## COMPANY STATEMENT

(Reference JVM410 Heater fuse removal)

Affected PCB 's will be marked as PCBP-00129-01 / 02 / 03 / 04

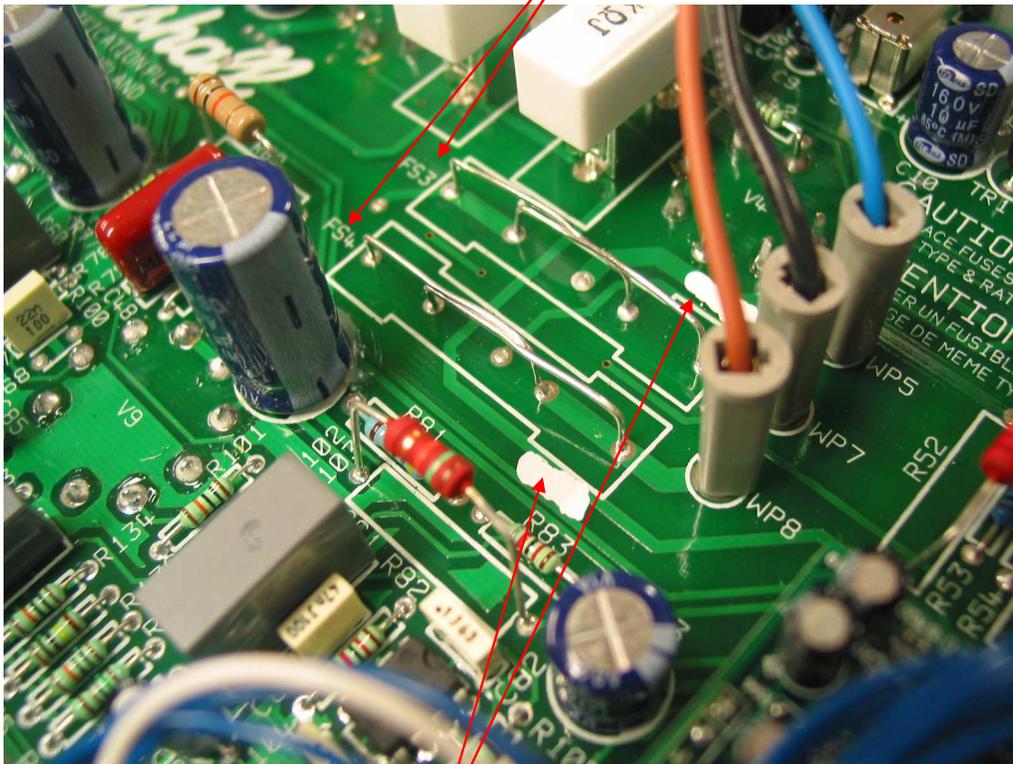
1. Remove fuses and fuse holders from location FS3 & FS4 on PCB and replace with 2 wire links per fuse soldered in positions shown below using WIRE-20045. 21swg Tinned link preformed to 26.5mm long and 5mm high.

2. Cover fuse ratings of FS3 & FS4 (T10A) marked on PCB silk screen with TIPP-EX.
